S307-03

DTC P0741 –
Torque Converter Clutch Does Not Lock Up –
Missing Seal Ring

MODEL 2000-02 MY
S-TYPE
VIN L00001-M44997

LOCATION OF OIL SEAL ON STATOR SHAFT

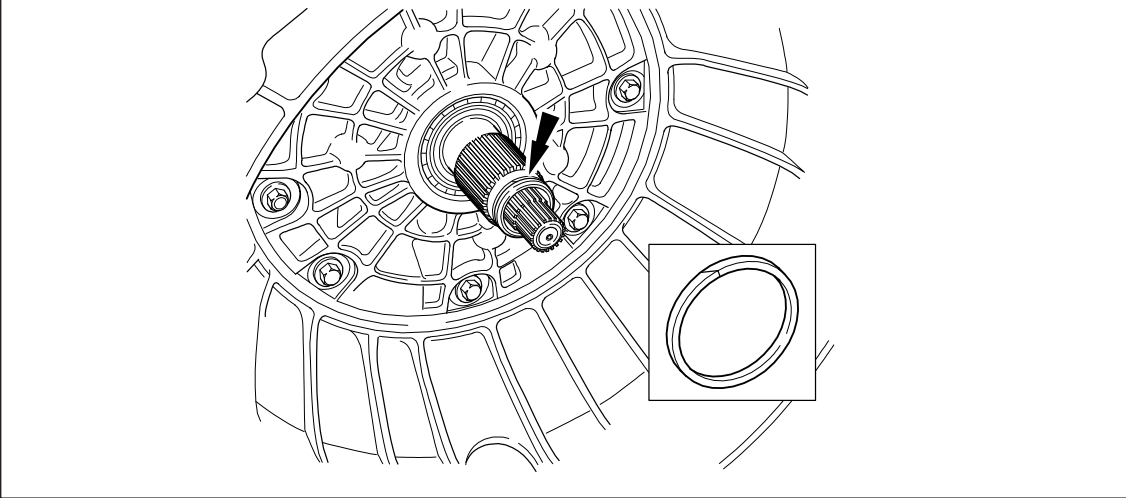
3. Inspect the stator shaft and determine if the seal is damaged or if no seal is present at the location shown in illustration 1.

4. If no transmission input shaft seal is installed, install a new seal.
5. Install the transmission torque converter.
6. Install the automatic transmission (see Global Technical Reference GTR Workshop Manual, section: 307-01, SRO 44.20.01).
7. Use WDS to carry out a transmission fluid level check (see Global Technical Reference GTR Workshop Manual, section: 307-01, General Procedures).
8. With WDS already connected, clear all DTCs from the Transmission Control Module (TCM).
